TOWN OF WARRENTON

COMBINED COMMENT LETTER

May 19, 2023

Project Name	Warrenton Data Center	
Project Number	SDP-2023-6	
Location	Corner of Blackwell Road and Lee Highway (6984-69-2419-000)	
Use	Data Center (Ordinance Section 3-4.12.3)	
Zoning	Industrial (I)	
Engineer/ Applicant Representative	Owner/Applicant	
John Wright, P.E. Bohler Engineering 28 Blackwell Park Lane, Suite 201 Warrenton, VA 20186 jwright@bohlereng.com 540-349-4500	Michael Gore, Point of Contact Amazon Data Services, Inc. P.O. Box 80416 ATTN: Real Estate Mgr (AWS) DCA62 Seattle, WA 98108 253-260-2494

Sheet C-101:

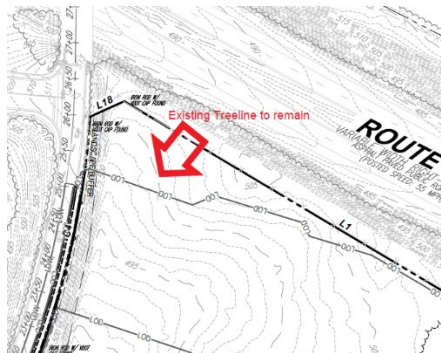
5. The property owner address is not the same as is listed on the Fauquier County Real Estate Records. Update address or provide clarification for difference.

Sheet C-301 & C-304:

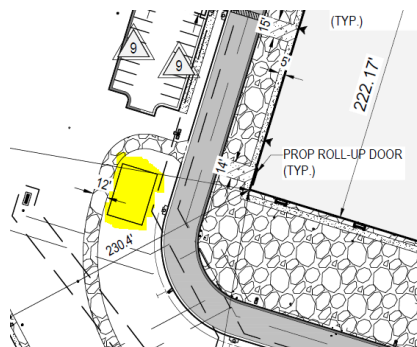
14. Provide details for **rectangular object** located between the access road and stormwater access way (See photo reference below)

Sheet C-302:

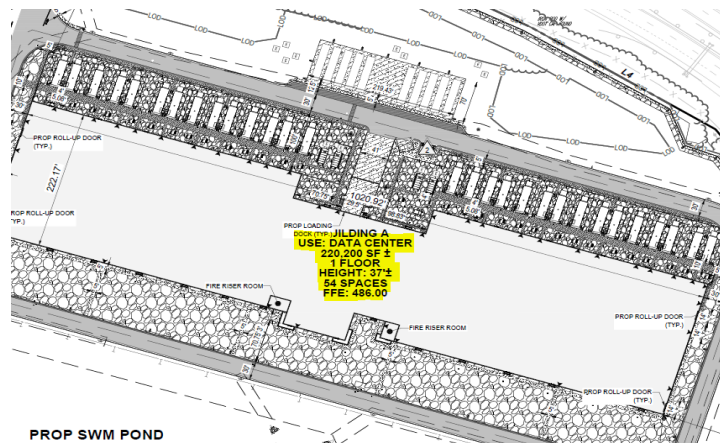
- 19. Revise building height to the actual calculated height throughout the plan, to show conformance with SUP condition #6c. (See photo reference below)

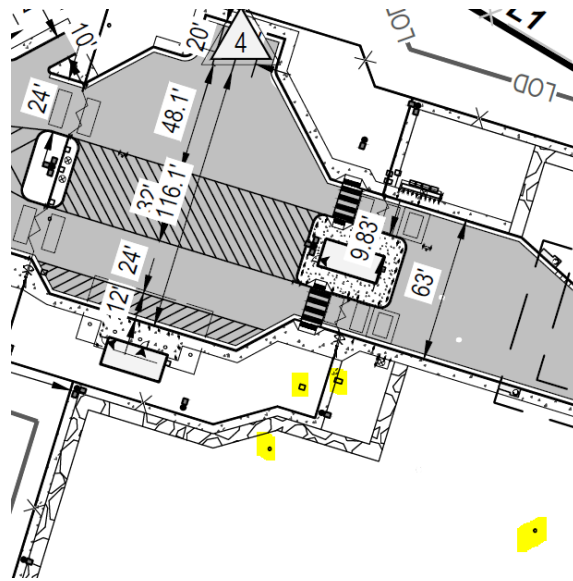
21. The 20-foot screen wall does not extend around the entire perimeter of the generator area as shown on the elevation drawings approved as a part of the SUP; revise the plan to show the wall extending the full length of this area in conformance with SUP approval condition #6.
22. Provide a cross-section/elevation detail for proposed perimeter fence, anti-dig pad, and gravel pathway.
23. Show the location of the required stop sign and stop bar at the entrance to the facility off of Blackwell Road.
24. Provide more information pertaining to the unlabeled boxes shown on the plan. (Photo reference provided below)

C-201A-C-201B-C-201C: ALTA/NSPS SURVEY (BY OTHERS)

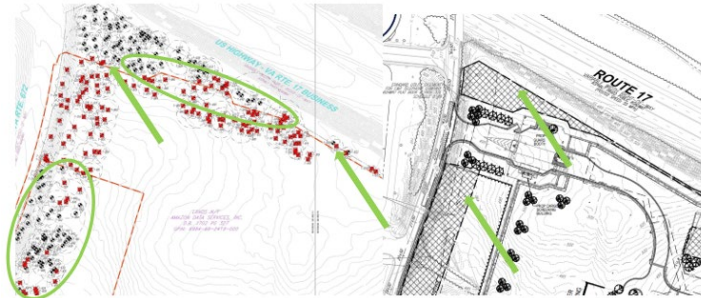
2. Label the material and diameter of the existing pipes that extend across W. Lee Hwy; see the picture below:

C-202A-C-202B-C-202C-C-202D-C-202E-C-202F-C-202G-C-202H: TREE REMOVAL BASE (BY OTHERS)

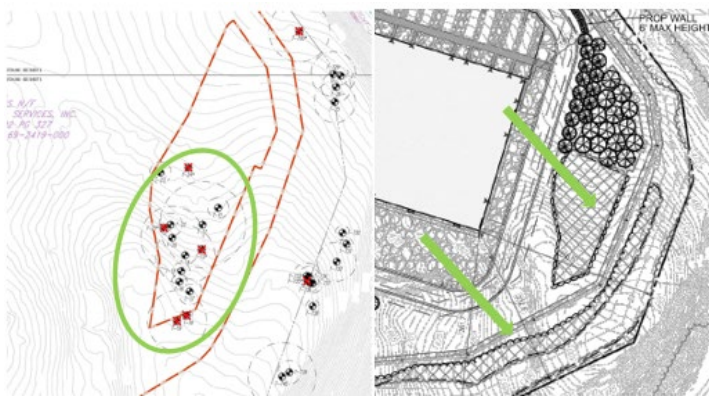
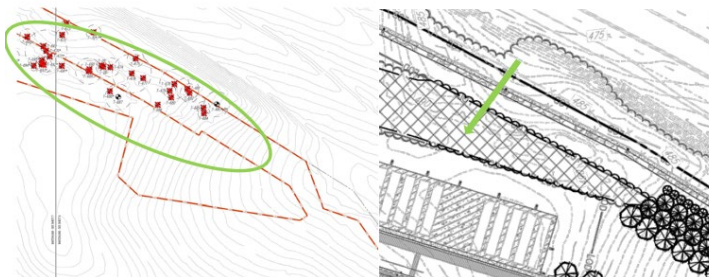
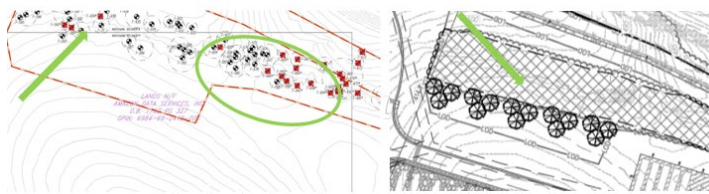
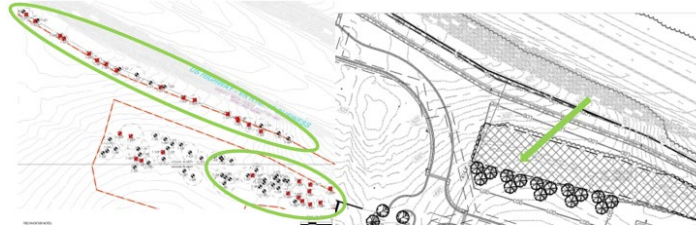
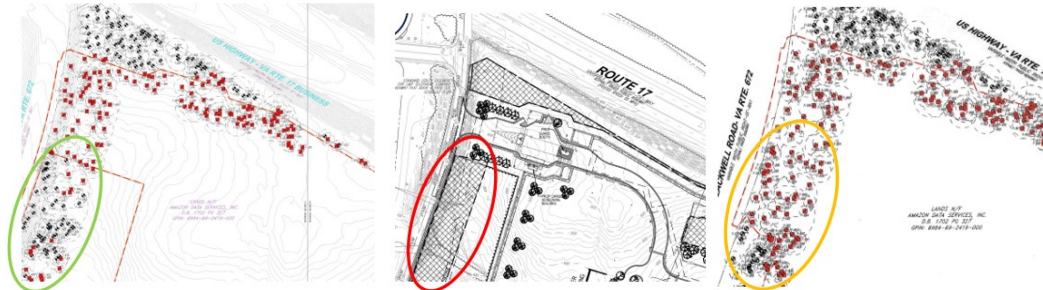
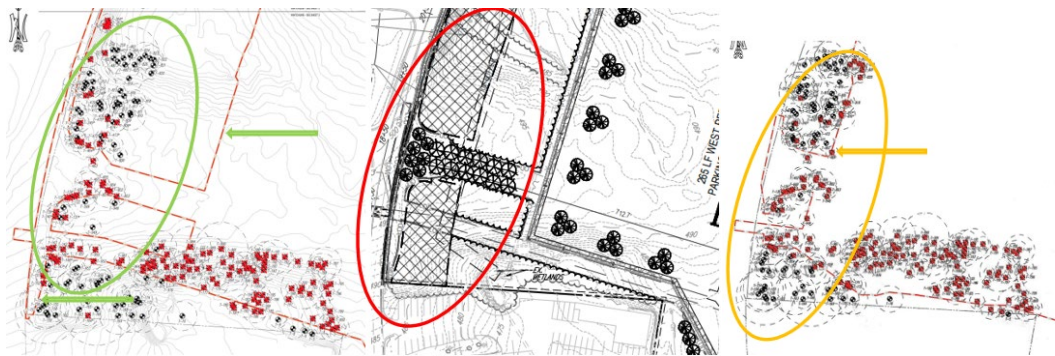
1. Indicate on the plan the **location of the existing wetlands**.
2. Correctly delineate and update the limits of disturbance and limits of work.
3. Clearly identify the tree preservation area. **The plans indicate trees to be removed in the preservation area and outside the limits of disturbance (find pictures below indicated in green). Are the roots of these trees going to be removed? How will the tree-cut trunks be removed from the preservation area without disturbing and damaging the vegetative ground cover? Please clarify and note in the plans how the remaining trees will be protected from construction activities without disturbing the ground. Otherwise, correctly delineate and increase the limits of disturbance and limits of work.**

- Per the SUP condition of approval #19, Tree Save, the applicant was requested to seek to minimize land disturbance and maximize on-site vegetation. It appears the limits of disturbance (LOD) indicated on the SUP plans (shown in red), and the proposed SDP plans (marked in green) are relatively the same; however, the Exhibit 1 Tree Study provided with the SUP (indicated in orange) and the SDP and SUP plans (shown in red and green) are different; please clarify.

C-203-C-204-C-205-C-206-C-207: OVERALL DEMOLITION PLAN

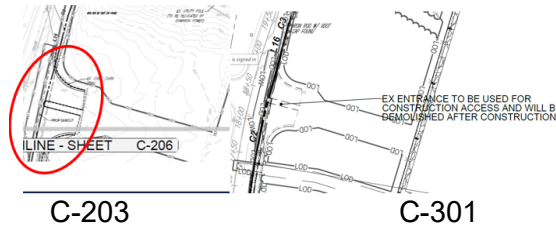
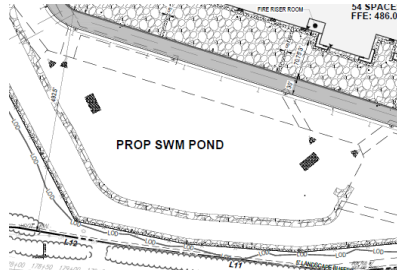
6. Label the material and diameter of the existing pipes that extend across W. Lee Hwy; see the picture below:

C-301-C-302-C-303-C-304-C-305: OVERALL SITE PLAN

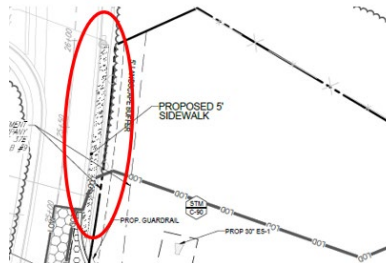
5. It is confusing to identify the location of the light-duty asphalt (same color as the pervious area, no color/white); please use another color to differentiate previous areas from asphalt.

C-401-C-402-C-403-C-404-C-405: OVERALL GRADING PLAN

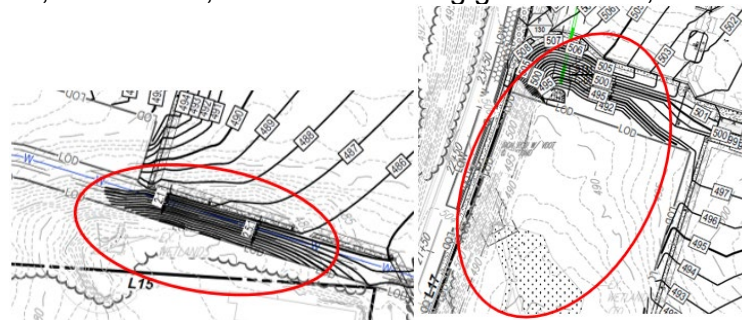
7. Indicate on the plans slopes bigger than 25%.

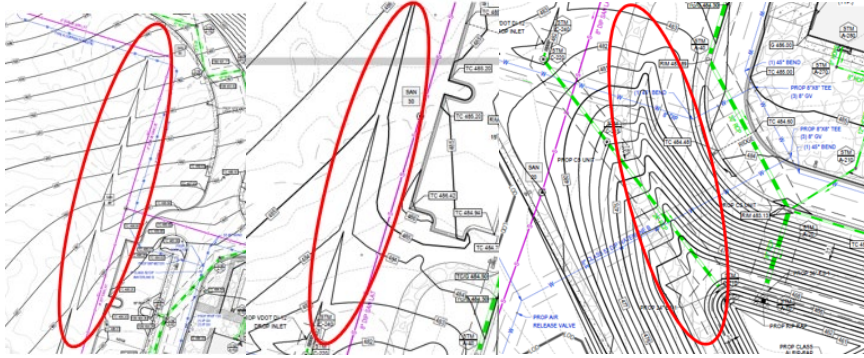
8. Where steep slopes are near or greater than 25%, provide slope calculations and ensure compliance with Article 9-17 of the Zoning Ordinance. Critical areas such as adjacent properties, rights-of-way, wetlands, and others, adequate protection methods to reduce excessive runoff, soil erosion, removal of existing ground cover, etc.

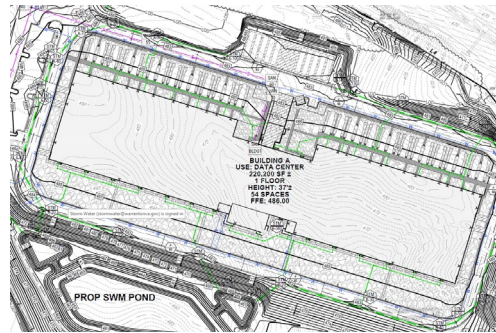
9. Provide the average percentage of slope for the following areas:

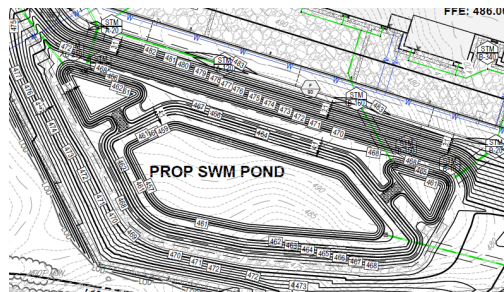
10. Please provide additional spot elevations for the building and surroundings.

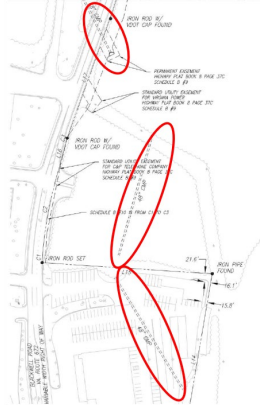
9. Please clarify the existing impervious area: 0.18 acres or 0.04 acres?

10. Indicate on the plan the existing pipes; see the picture below:

C-407: POST-DEVELOPMENT DRAINAGE PLAN

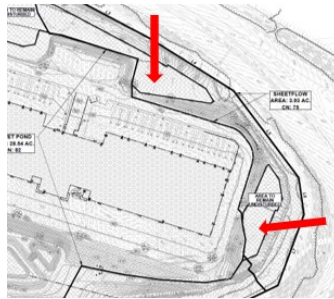
- 5. Please clarify if the protected area indicated below is included in the 3.93 ac. Otherwise, change the weight of the line.

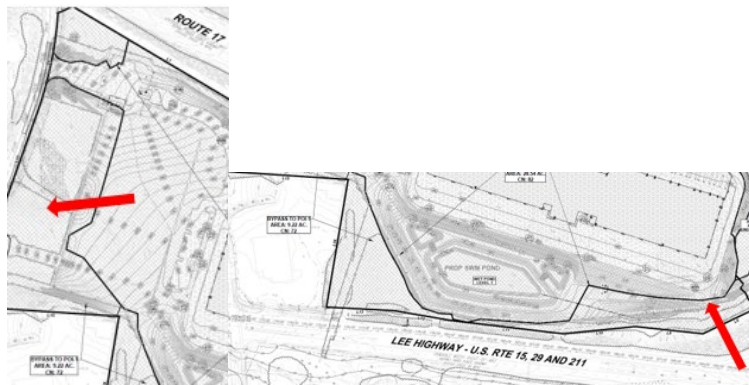
- 6. Please clarify if the area indicated below is included in the 9.22 ac.

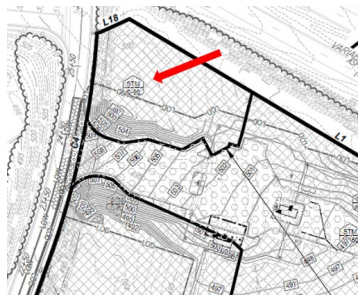
- 7. Please clarify where the area indicated below is included.

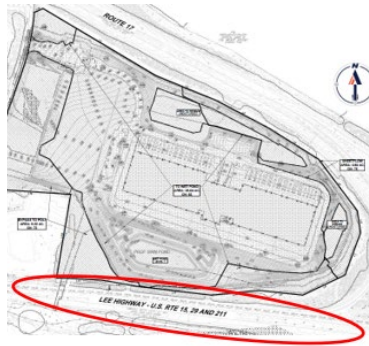
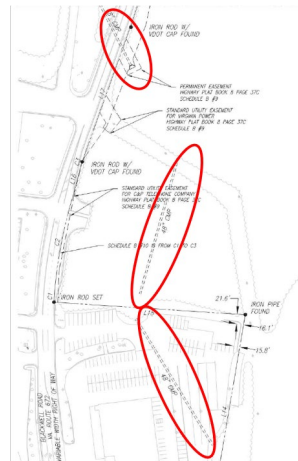
- 8. Indicate on the plan the existing pipes that extend across W. Lee Hwy. Please, clarify how the flow under the existing culverts (four in total) under Lee Highway to the stream

on the east side is flowing with this plan. Indicate with arrows the direction of the flow. Provide calculations.

9. Indicate on the plan the POI-2.
10. Indicate on the plan the existing pipes; see the picture below:

C-501-C-502-C-503-C-504-C-505: OVERALL UTILITY PLAN

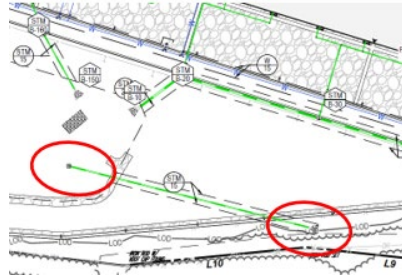
6. Label all the SW pipes and inlets: diameter, slope, material, and inlets. See the picture below:

C-506 C-507 C-508: UTILITY COMPUTATIONS

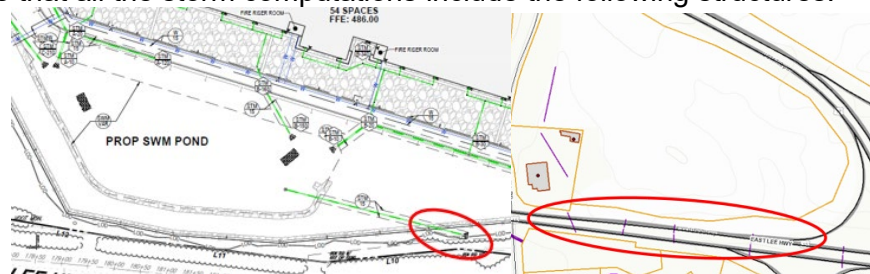
1. Refer to Stormwater (SW) Public Works Review Comments # 6-7-8-9-10-11-12.
2. Ensure that all the storm computations include the following structures:

C-601 EROSION AND SEDIMENT CONTROL PLAN PHASE I

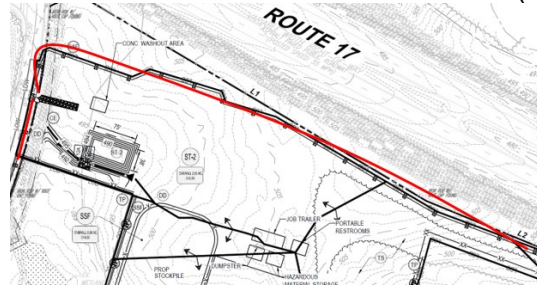
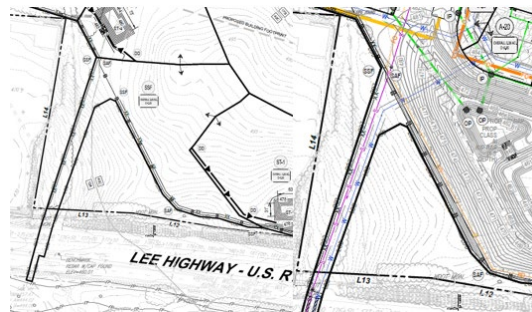
4. Demonstrate drainage area to silt fence does not exceed ¼ acre per 100 LF. [ZO 5-10.1C, VESCH 3.05].
5. Additional silt fence is needed in the areas indicated in red (find below):

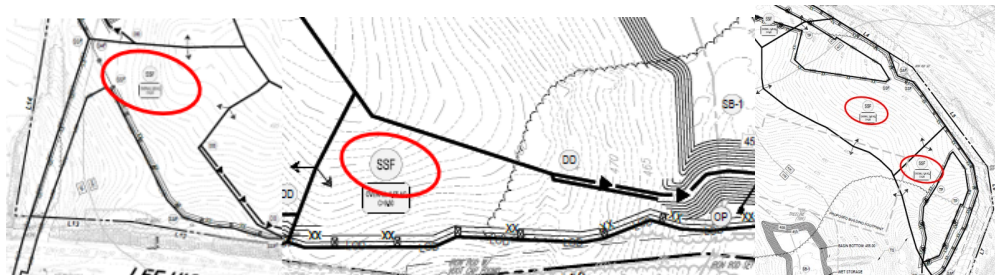
- a. Missing the name of the areas indicated below. “SSF” appears to be a typo.

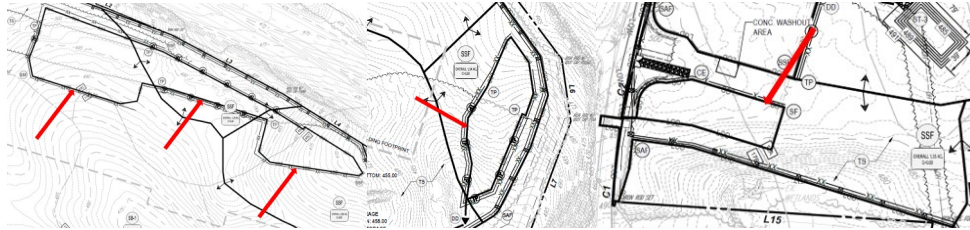
- b. Please clarify if the following protected areas are included on the 15.5 ac, 1.29 ac, 2.82 ac., 1.34 ac., or 1.35 ac. Otherwise, change the weight of the line.

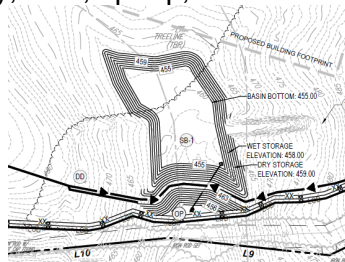
c. Please clarify the discrepancies between ESC Phase I and 2 in relation to the preservation areas (ST-2 vs. C-90, A-170, etc.).

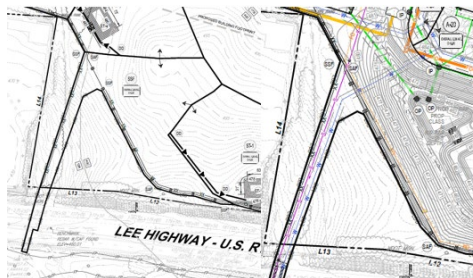
- Max. High (H) and max. Slope.
- Separation between the stockpile and the ESC measures.
- Stockpile entrance (to be located upslope side).

C-602 EROSION AND SEDIMENT CONTROL PLAN PHASE II

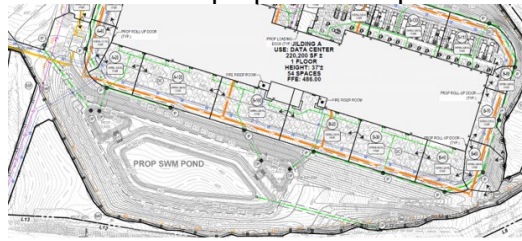
- e. Identify the total area for the proposed SW pond and surroundings.

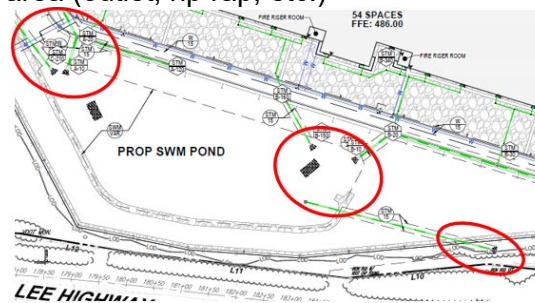
1. Correctly delineate and increase the limits of disturbance and/or limits of work because of the new landscaping; see pictures below.
